2017 PLANNING COMMISSION

Bellevue Planning Commission

7:30 PM – 9:30 PM	Study Session <i>Downtown Livability – Review of Draft Downtown Land Use Code Amendment (LUCA)</i> Staff: Carol Helland, Code and Policy Development Director, Development Services Dept. Patricia Byers, Code Development Manager, Development Services Dept.; Emil King, AICP, Strategic Planning Manager, Planning & Community Development Dept.
-------------------	---

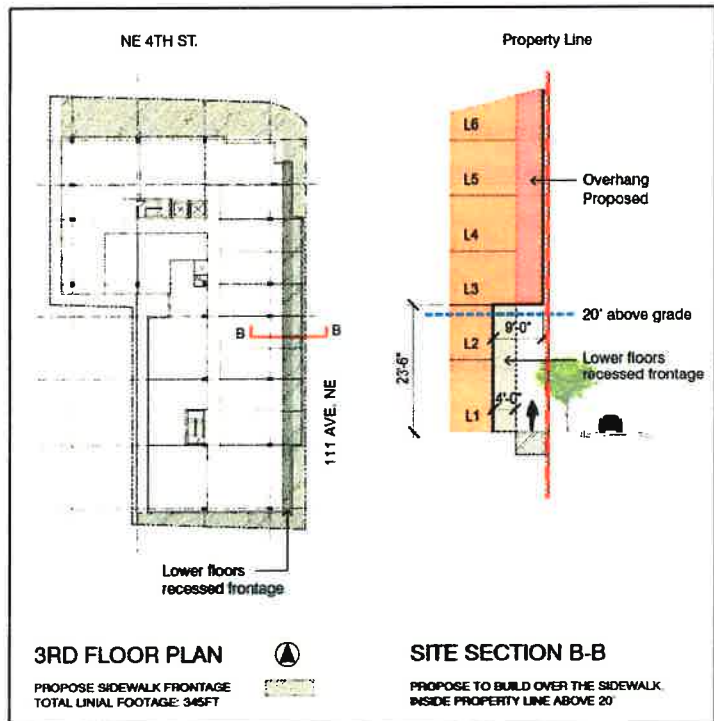
Linear Buffer (.110.C). Given your willingness to eliminate the linear buffer for A-3, please consider reducing the 20' linear buffer for A-2 to 20' from the curb edge instead of 20' from the back of the sidewalk. Currently the code is interpreted as a 12' sidewalk plus the 20' buffer for a total of 32'.

Right to Build to Sidewalk. The adjacent diagram shows the floorplan and elevation of our proposed residential project on the 4th & 111th site. The small site makes it very difficult to set back the building and have enough room to efficiently design residential units. The figure on the left shows that even if the building can be built to the property line, a typical 35' deep row of residential units is only achievable on the east side of the building. As shown on the right diagram, the sidewalk and enhanced streetscape requirements push the ground floor back nine feet from the property line. If we are not allowed to build back to our property line it would eliminate the grey area on the east side of the building on every floor. Maintaining this up to 20' in elevation is not ideal, but it's workable.

Proposed solution: Add a new Subsection .060.2.a.iii. "On Mixed Streets and Neighborhood Streets, Building structure, external decks and balconies are permitted to extend over the sidewalk and enhanced streetscape area to the property line above a minimum clearance of 20 feet above the right-of-way, except when a setback or stepback precludes such extension."

Figure 20.25A.060.A.3

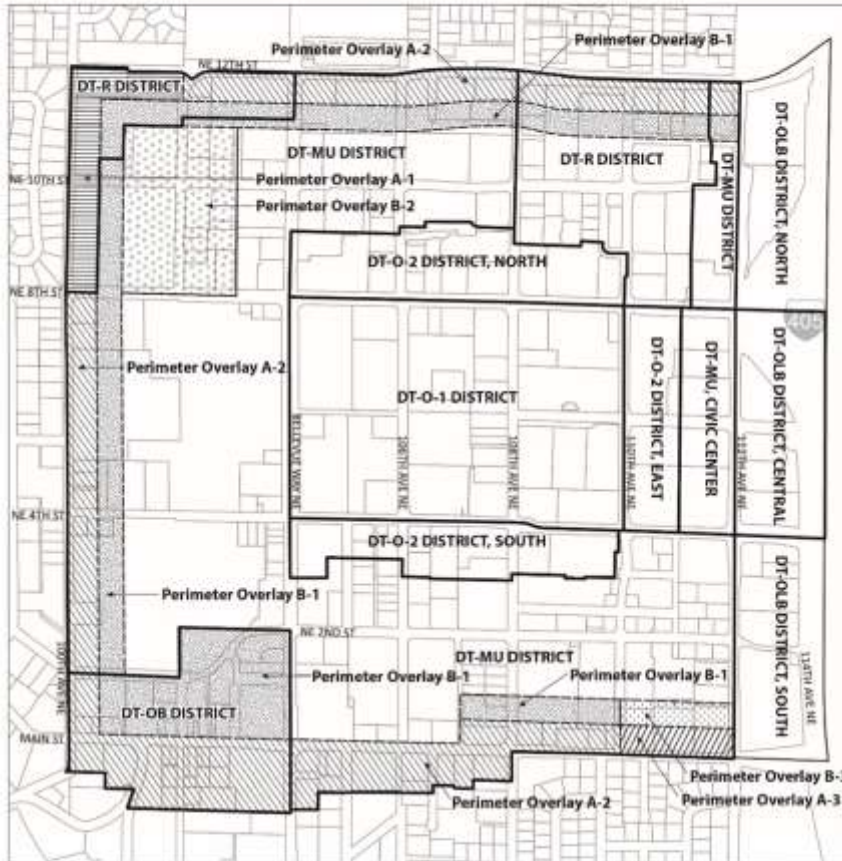
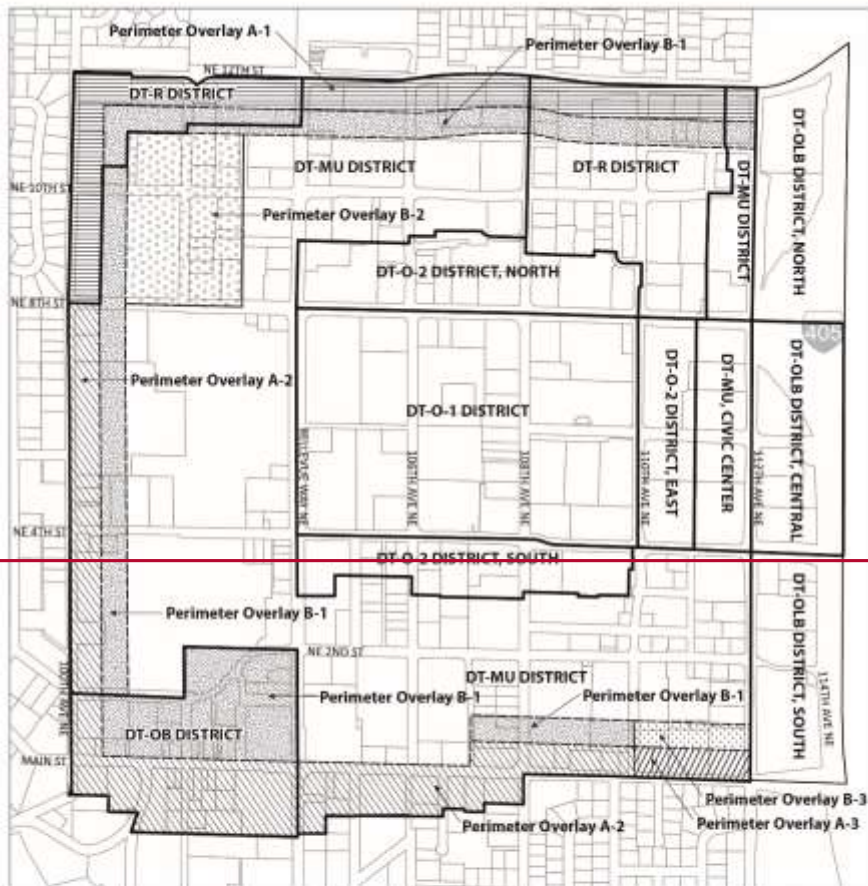
INSERT MAP Initial PC Direction 4.19.17

Commented [BT(44)]: Initial PC direction on 4.19.17 was to substitute Perimeter Overlay A-2 in for Perimeter Overlay A-1 on 112th Ave. NE from 102nd Ave. NE to 112th Ave. NE

Figure 20.25A.090.A.1

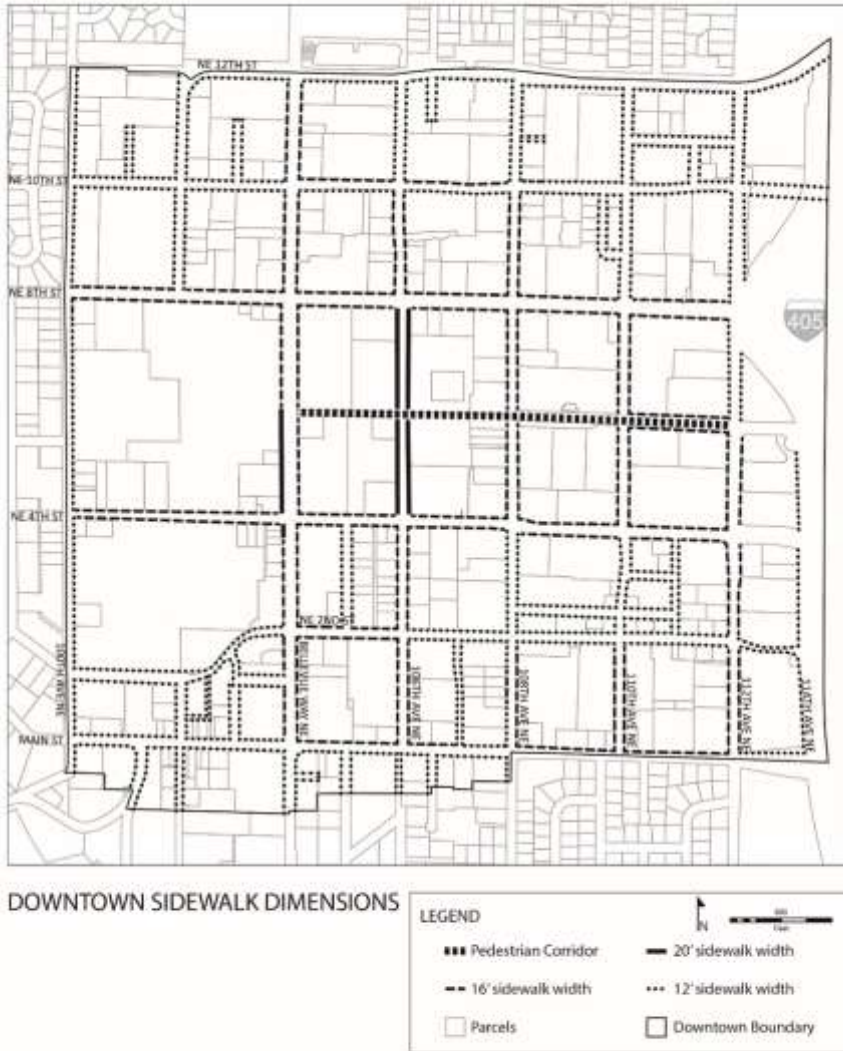
Commented [BT(130): PC initial direction on 4.19.17 removed the requirement for sidewalks below the freeway access on NE 4th and NE 6th between 112th Ave. NE and 114th Ave. NE.

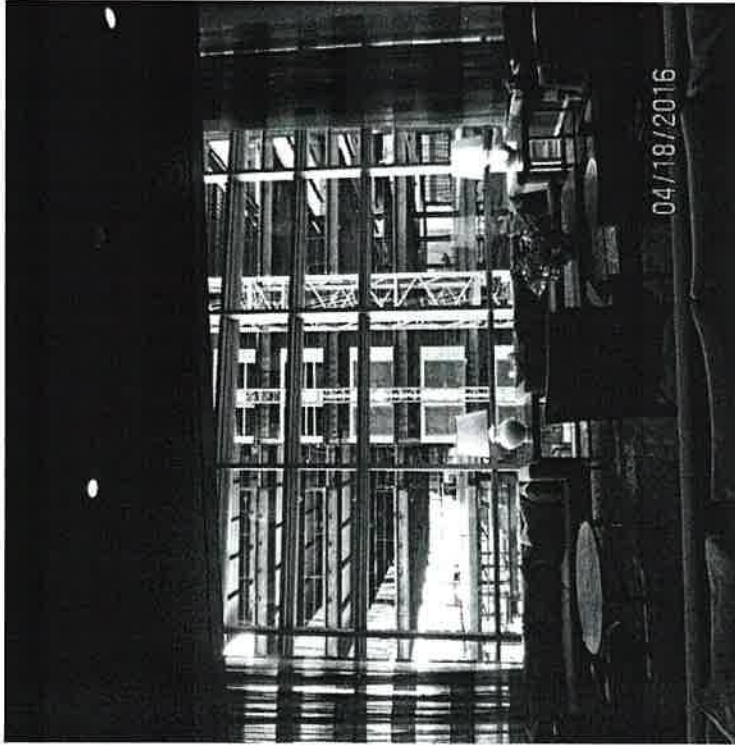
Livability for downtown residents?
After: 80' between Centre 425 and Bellevue Towers?

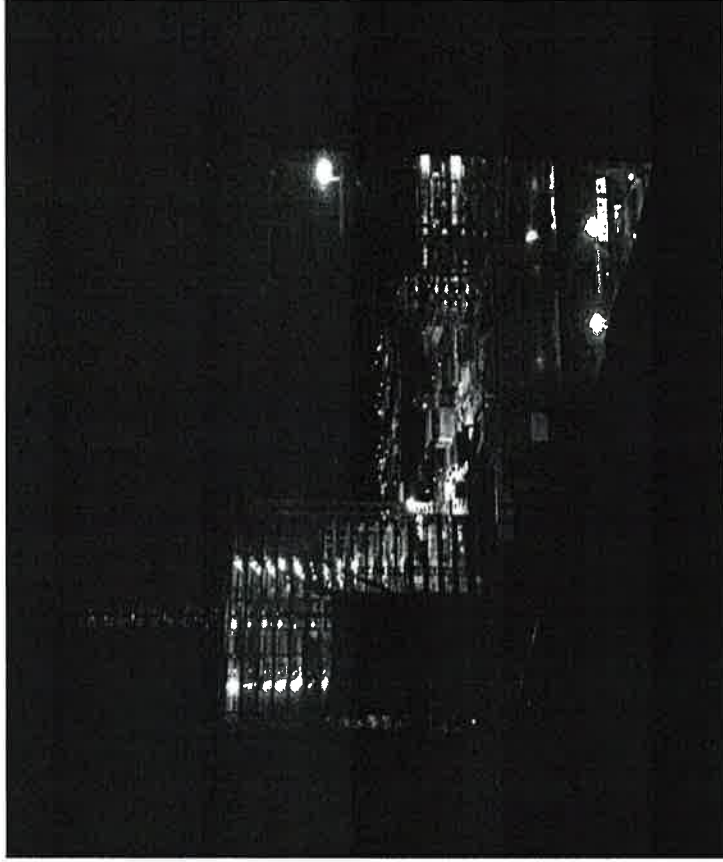
Livability for Downtown Residents?
Before and after: Sunsets vs. bright lights at night.
